**CHANGE REVIEW PANEL REPORT ON
ILC-CR-0016: LUMINOSITY IMPROVEMENT AT
250GEV CM**

EDMS No:
D*01xxxx5

Change Request ILC-CR-0016 “Luminosity improvement at 250GeV CM” (EDMS ID [D*1159725](#)) was submitted to the TCMB on 25.9.2017.

Figure 1: Damping Ring arc cell in TDR configuration. Bending dipoles are shown in green.

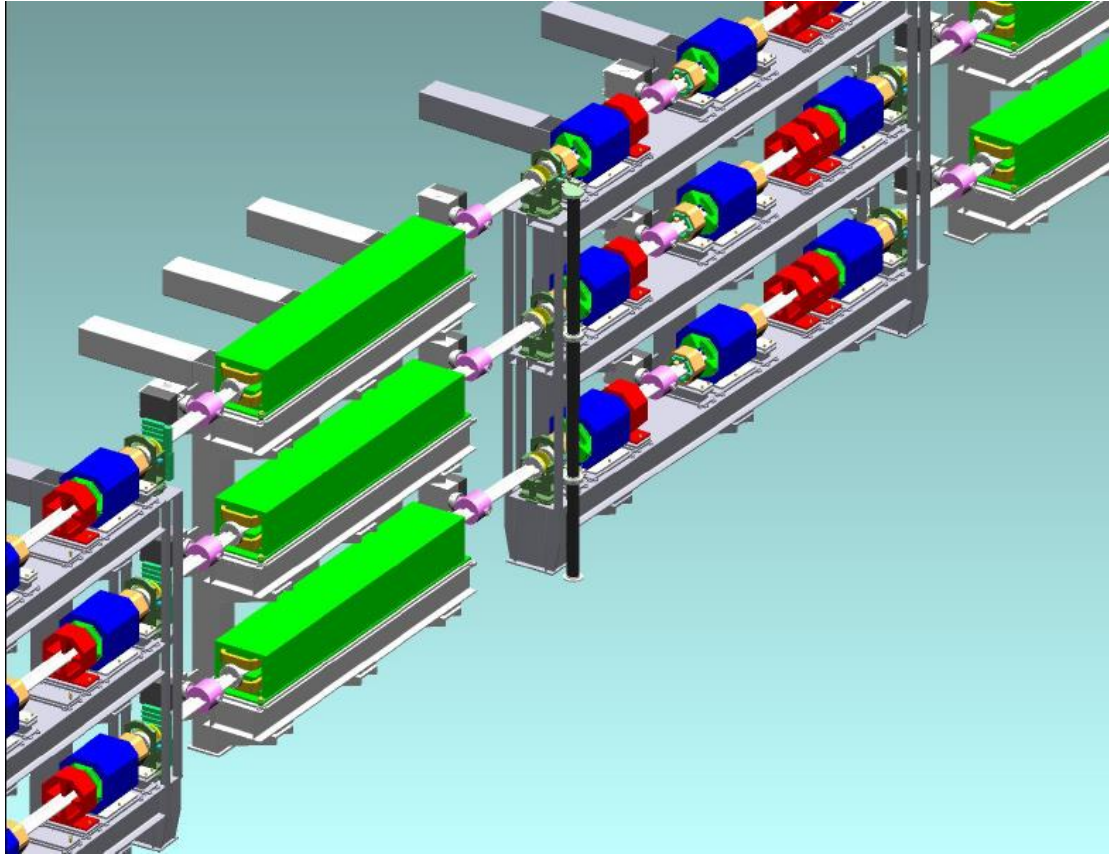
Finding: We find it credible that the proposed change of the DR lattice (using the adjacent drift sections around the bending dipoles in the arcs to make the bends longer) lead to the emittance reduction described in the DR.

Finding: We find it credible that the proposed change in the DR lattice can be implemented without significant increase of costs, performance or technical risk.

Fig. 1 shows a view of a CAD model ([D*01207043](#)) with the original dipoles, which indicates that there is sufficient space to accommodate longer bending dipoles as proposed in the CR.

Recommendation: We recommend conducting a study that evaluates the impact of the changed bending magnet length on the mechanical layout of the DR arc cell.
